Airworthiness Directive

AD No.: 2022-0243

A330 and A340 aeroplanes

ATA 36 – Pneumatic – Overheat Detection System Sensing Elements – Inspection

Figure 4-50. Identification Markings on Coaxial SE Male (Pin) Connector

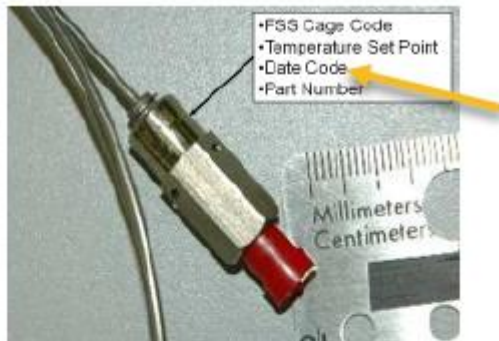
For the reasons described above, this AD requires a one-time special detailed inspection (SDI) of each affected part installed at an affected position, as defined in this AD, and, depending on findings, replacement of the affected part with a serviceable part. Appendix 1 of this AD provides information how to identify affected parts (P/N and date code).
